SERVICE LETTER

No. 844

Piper Aircraft Corporation

Heater System Rewiring

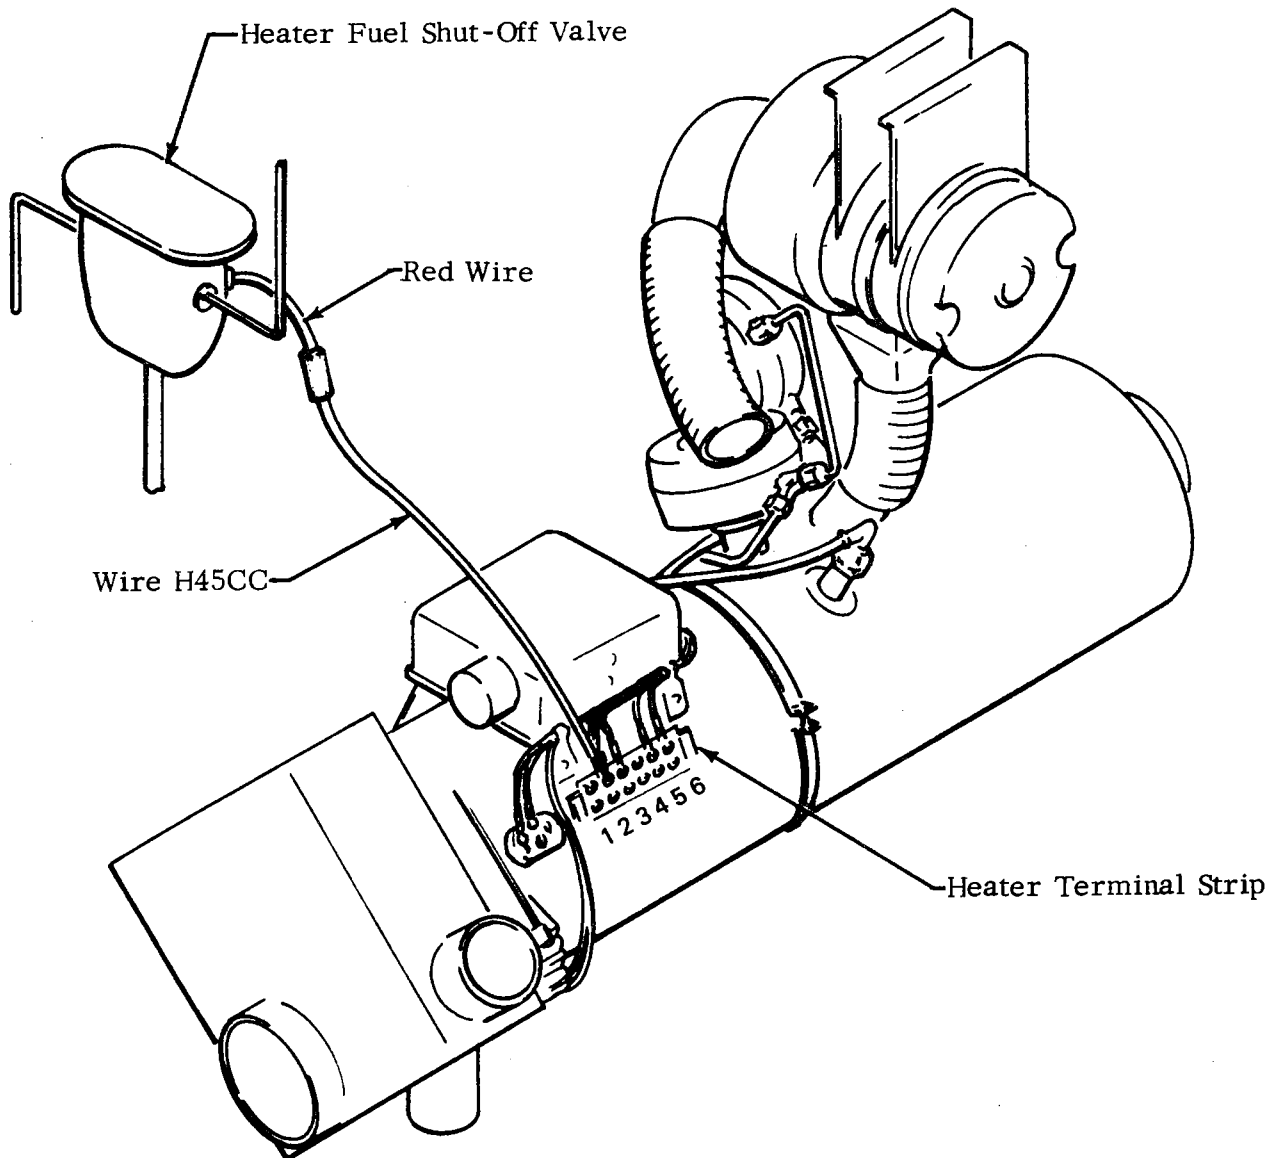
The heater system electrical wiring on the above referenced aircraft de-activates only the heater (internal) fuel solenoid/valve when the "overheat switch" is tripped.

This service release provides instructions to rewire (relocation of one wire) the heater terminal strip to allow shut off of the remote (sta. 57 bulkhead) mounted heater fuel shut off valve simultaneously with the heater (internal) fuel solenoid/valve. This product refinement provides additional protection to the heater by insuring immediate termination of fuel flow.

1. Remove the right access panel from the fuselage nose section to gain access to the heater assembly.
2. Relocate wire H45CC from terminal #1, of heater terminal strip, to terminal #2 as shown.
3. Reinstall fuselage access panel.
4. Make proper logbook entry of Service Letter compliance.
